HORSHAM DISTRICT COUNCIL CONSULTATION

TO:	Horsham District Council – Planning Dept
LOCATION:	New Place Nurseries London Road Pulborough West Sussex
DESCRIPTION:	Reserved Matters application pursuant to Outline Planning Consent DC/21/2321, as varied by application DC/24/1204. The Reserved Matters comprise details of 160 no dwellings, associated internal access roads, parking and landscaping for areas east of the right of way. Details of appearance, landscaping, layout and scale to be considered.
REFERENCE:	DC/24/1676
RE-CONSULT:	1 st set of comments in black 2 nd set of comments in blue
RECOMMENDATION:	Objection / More Information / Modification Objection / More Information / Modification

2nd set of comments

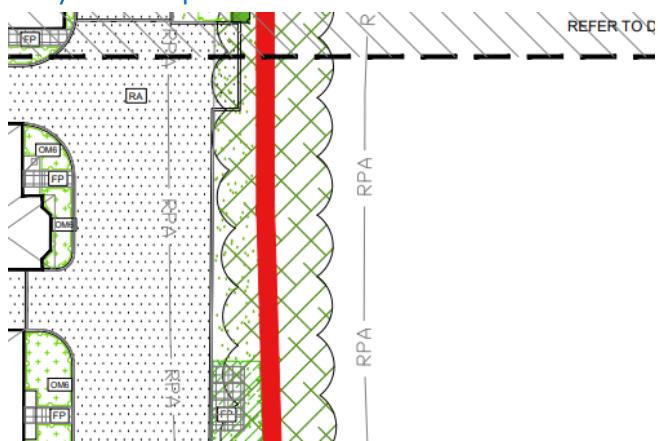
We consider this narrowing to be significant, as opposed to slight [see design evolution below]. The previously approved corridor shape reinforced the countryside character by virtue of a wide cone absent from development, positively contributing to the long distance views and thus recreational enjoyment of users of the PRoW. The newly proposed built form within this cone creates short and medium distance views that while unlikely to fully block views of the SDNP, detracts from the sense of place and the countryside setting. We request that framework plan is amended to that previously approved or further consideration made in order to meet aims and objectives as cited above.

If this is disagreed with, we request a verified photomontage of the proposals from EDP LVA Viewpoint 2/ Finc Viewpoint 1 to demonstrate that the long distance views are retained and enhanced.

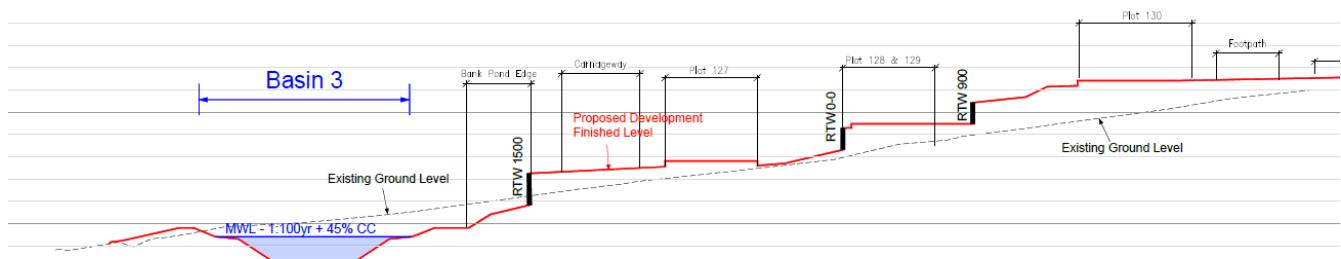
15. Plan demonstrating coordination of landscape proposals, tree planting, underground services and lighting. We note that the main avenue of trees is included within drainage proposals, however there are discrepancies with this and the landscaping proposals. Notwithstanding this, the entire tree scheme must be reflected.

Not addressed.

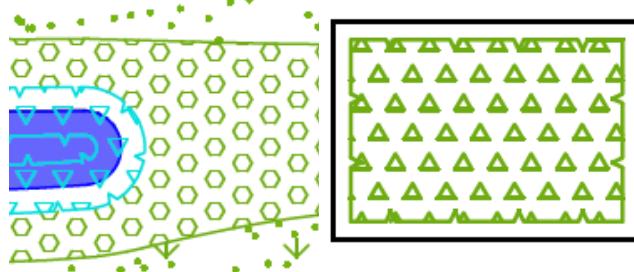
21. North-south tree lines such as G18 are proposed to be removed in Arboricultural plans, however these are shown as 'Existing trees / vegetation retained' in the Landscape Masterplan/ approved parameter plan. As above, the Landscaping Proposals do not cover this area, therefore further information is required to be submitted. We request that these are retained as they're seen as key structural feature that positively contributes to the landscape framework and to embed the scheme into the landscape.

We note the updated AIA which details, '*Poplar collection to be repollarded (to previous pruning points) components with excessively decayed boles to be removed*'. In order to ensure the longevity of this landscape feature and enhance it in line with the approved development objectives, we request that every removed tree is replaced with a species listed under 'Native Parkland Trees' within the Plant Schedule. Please include details within the landscape plans and planting schedule.

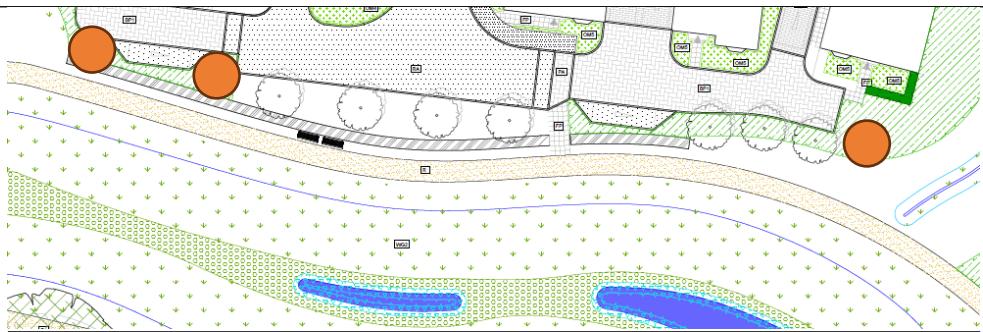
29. We note that some areas on the eastern boundary appear to be left clear of planting – see examples below. Given that our comments under PE/24/0081 and DC/21 both state to pull, 'the built form edge away from the eastern boundary to introduce woodland shaw / belt planting of native species', we continue to recommend that these areas are densely planted to assist the transition into rural countryside.

Layout has changed – see point 14. Closed.

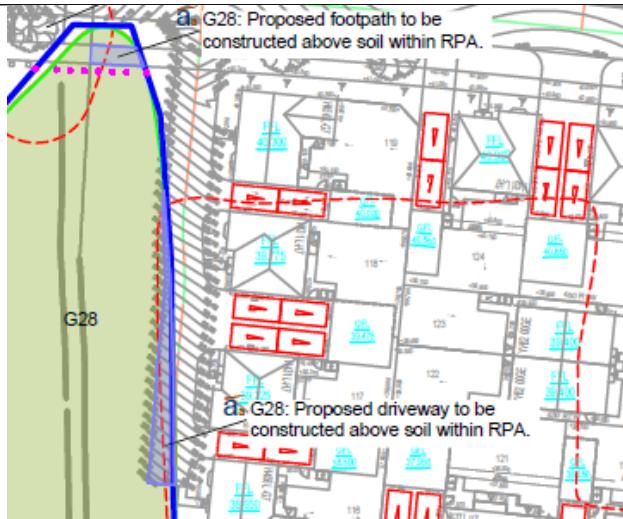
34. We request that the road layout is adjusted to avoid the RPA of Category A G28, which is classified as a 'high value collection of trees'. Given the undeveloped nature of the site, and approved parameter plan, it is required that RPAs are avoided in order to retain and protect existing trees and hedgerows, as per aims set out within the Design and Access Statement, as well as policy 33 of the HDPF.

Closed, with thanks.

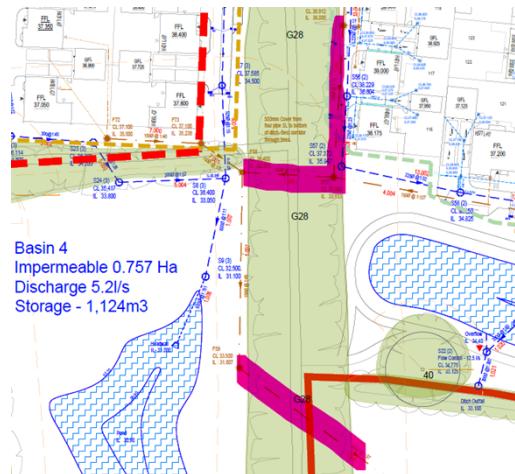
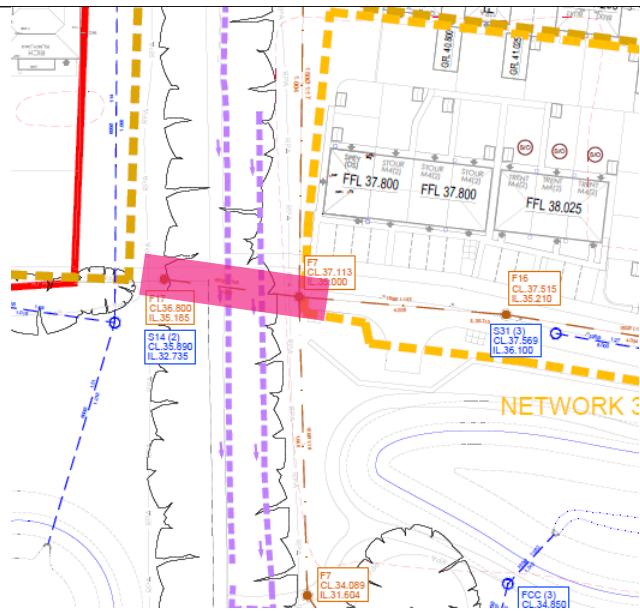
- a. Of key concern is aforementioned Category A G28, where multiple drainage paths are proposed [highlighted in pink, below]. We recommend that drainage avoids the RPAs of G28 entirely and that other routes are explored. If it can be demonstrated that there is no alternative option but to encroach G28, only one drainage trench should be proposed at minimum and advice from the HDC Arboriculturist should be sought in order to minimise adverse effects.

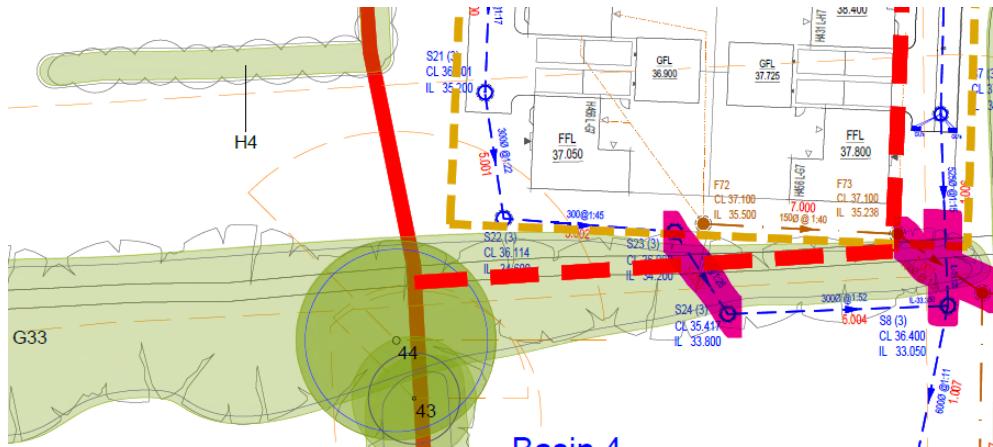
While it is welcomed that the southern drainage run has been removed, the northern run remains [highlighted in pink, below]. Given that the foul run no longer connects to the western parcel, we request that it is removed entirely to avoid Category A G28.

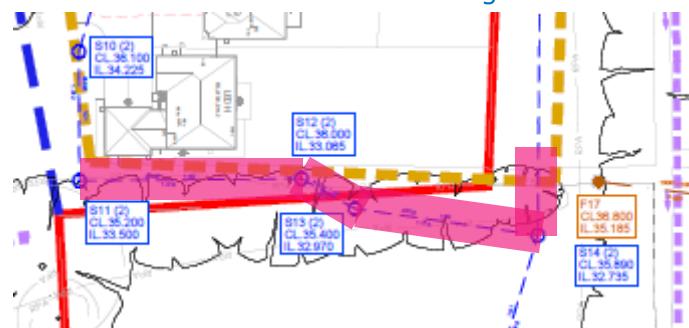
b. As above, multiple drainage routes pass through G33 [highlighted in pink, below]. While this group of trees is of lesser quality than G28, it still positively contributes to the character of the area, therefore should be retained and safeguarded. Please modify proposals to avoid and minimise disturbance to the rooting medium.

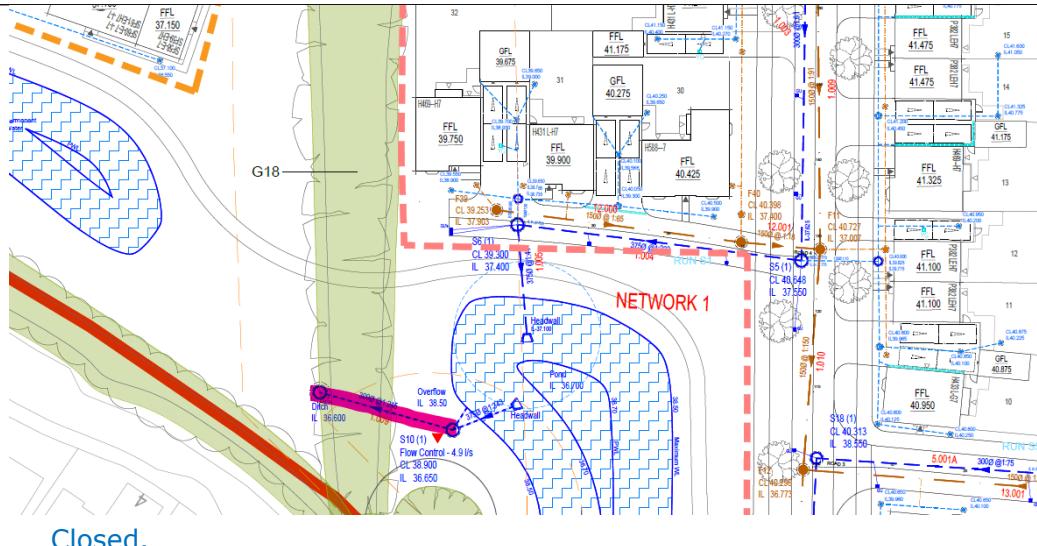
While one route has been removed, with thanks, further routes remain [highlighted in pink, below] and the updated orientation will cause further conflict with G33 and associated RPAs. As previously requested, please modify proposals to avoid and minimise disturbance to the trees and rooting medium.

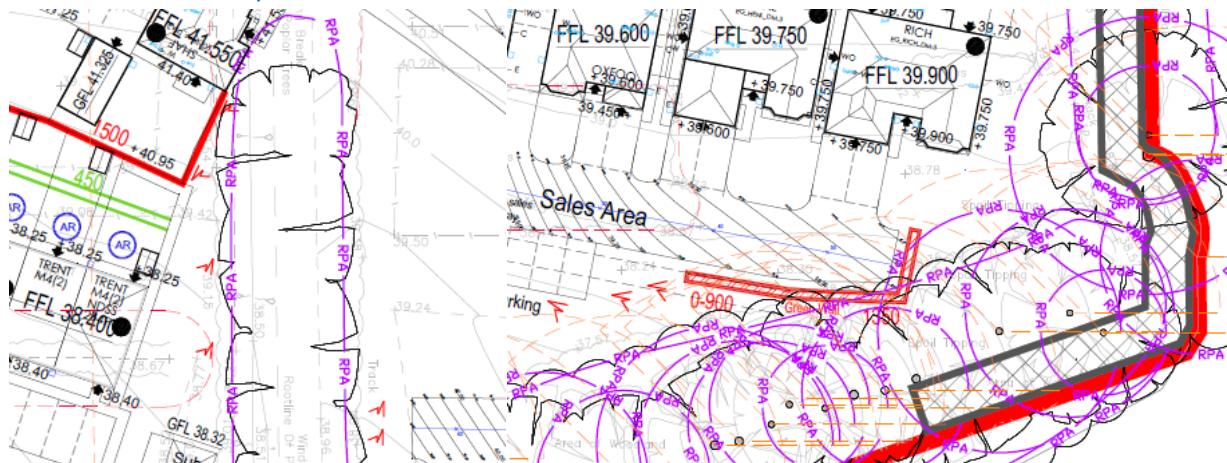
39. As per point 18, the levels plan remains unclear. Contour lines and gradients are required to ensure the suitability of scheme. We highlight the slopes indicated below.

40. Further, we note multiple instances of 'green wall' in place of a retaining wall. Clarification is requested.

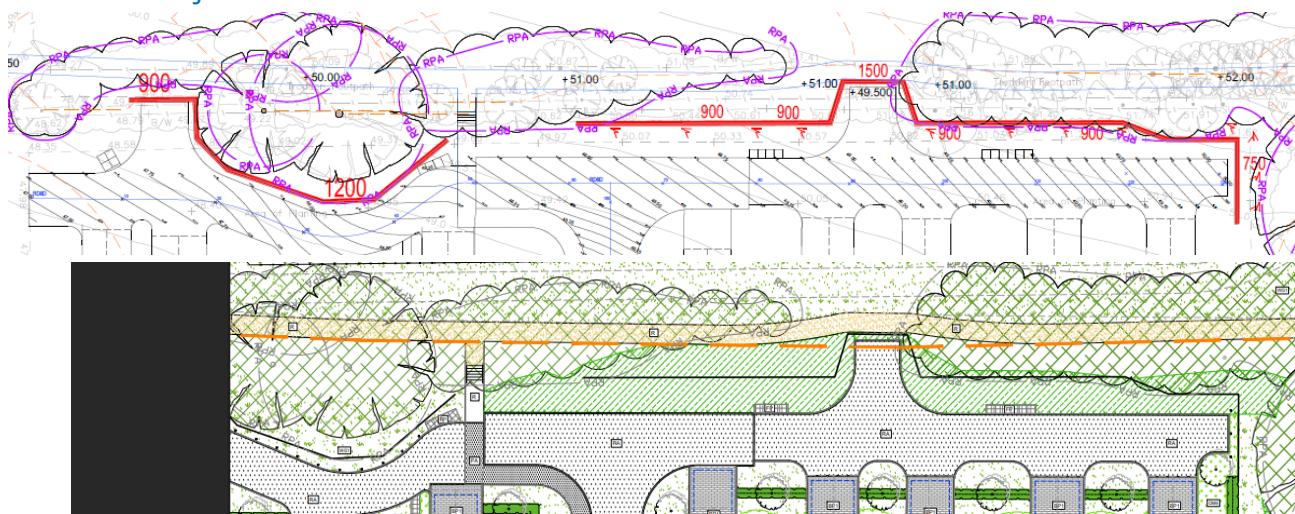
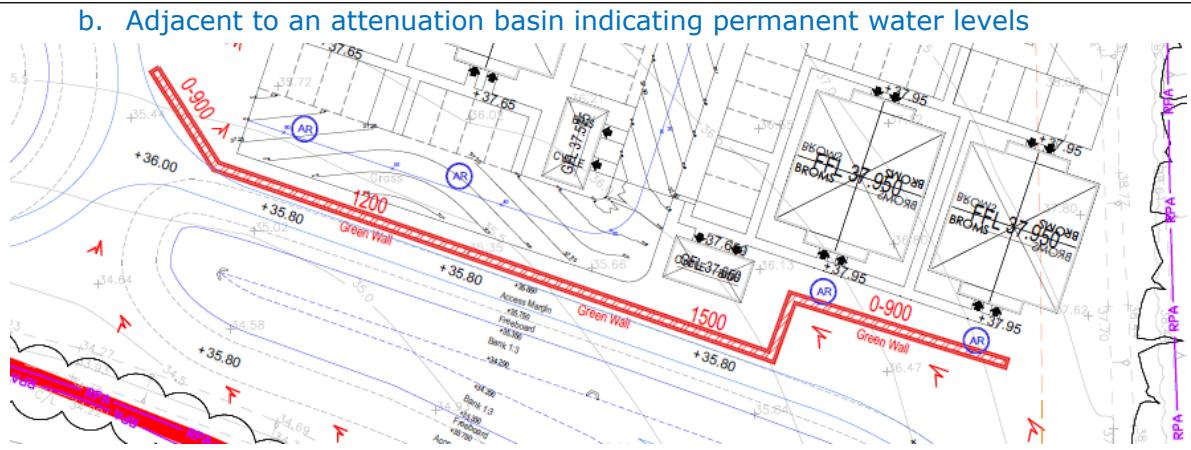
42. As previously commented, concern is raised in regard to drops of 1.5m and would require balustrades to be added. We note further instances of these drops on account of the changes to proposals, two of which are highlighted below as unacceptable:

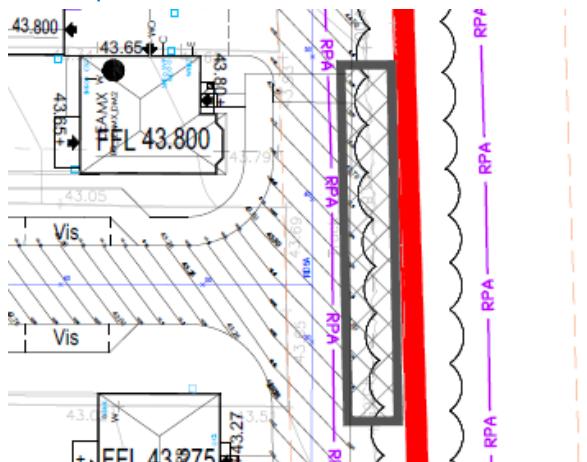
a. Adjacent to the PRoW

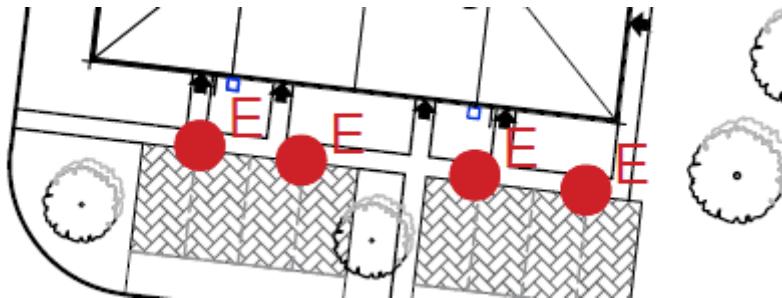
44. We note further inconsistency in plans. The central treeline is retained within the masterplan [below, left] and partially removed in the Tree Protection Plan [below, right]. As previously commented, no Combined Hard and Soft Landscape Plans have been provided for this area. We request clarification and that plans are updated for consistency, noting that any removed trees should be replaced, as per point 21.

45. We note the wildflower meadow in the northeastern open space parcel is fenced off. Clarification is requested as to its purpose, given the original aims of this area being proposed as a Countryside Park.
